SPECTRA ENGINEERING PTY LTD

MX800 Important Firmware Update

MOTHERBOARD BUILD VERSION C OR LESS WITH NEW RELEASE FIRMWARE

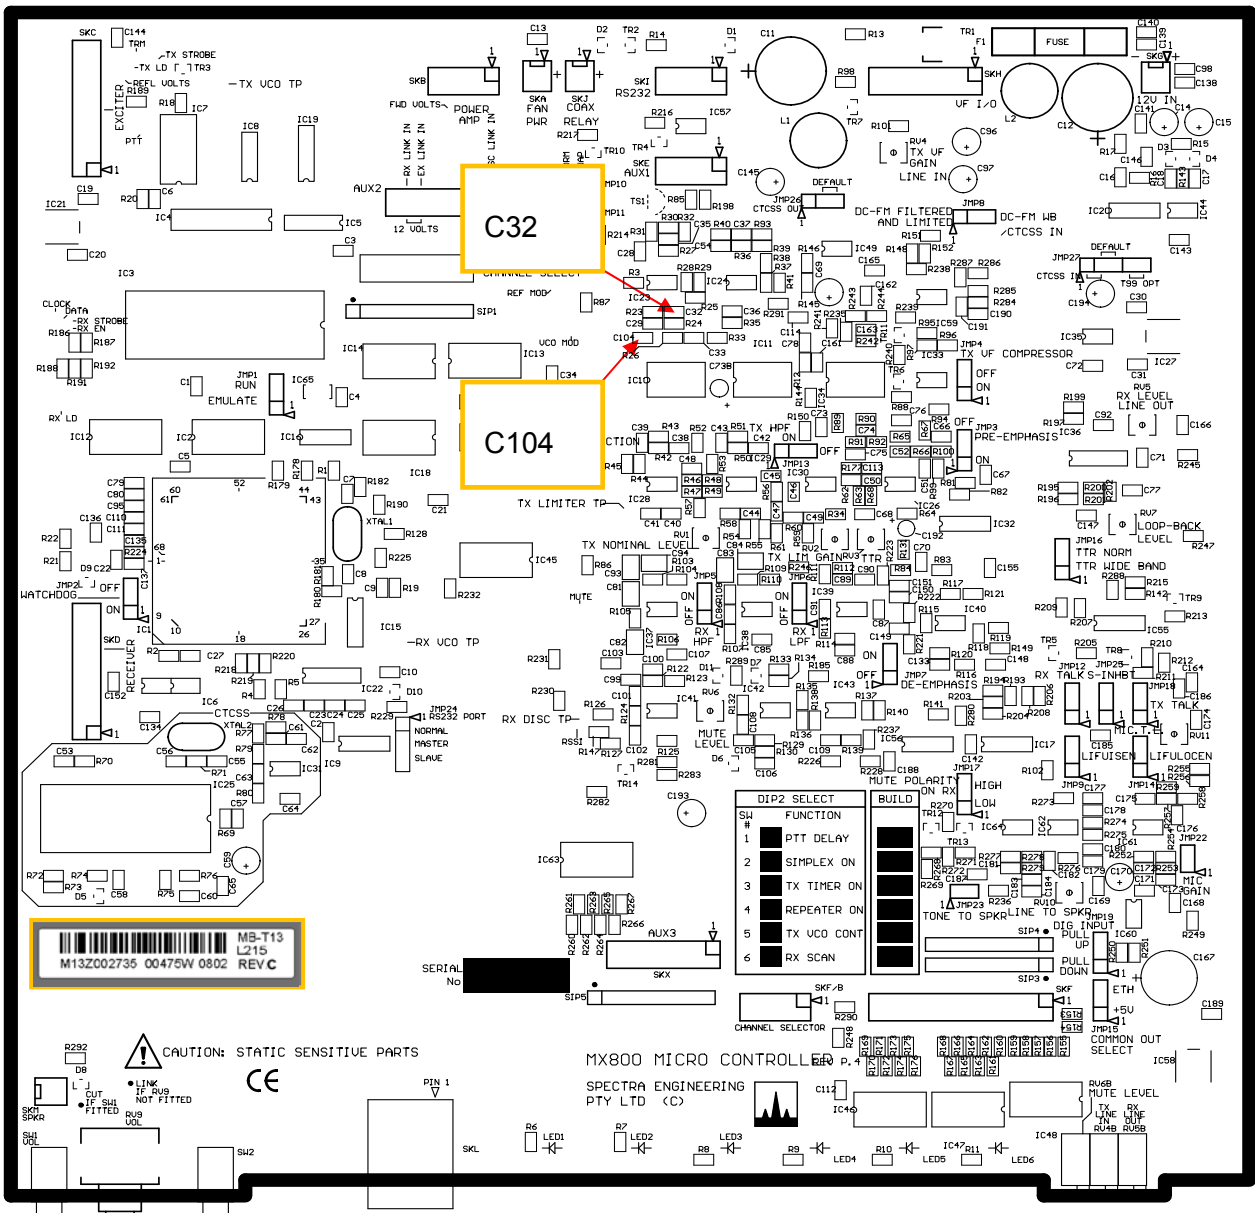
3. Mother Board controller PCB's that have been upgraded at factory prior to shipments have been fitted with two labels as shown below.

Factory Modifications have been carried out.
 Mother Board is now upgraded to **REV D** assembly.
No modifications required, ok to use new firmware $\geq 3.5.14$.
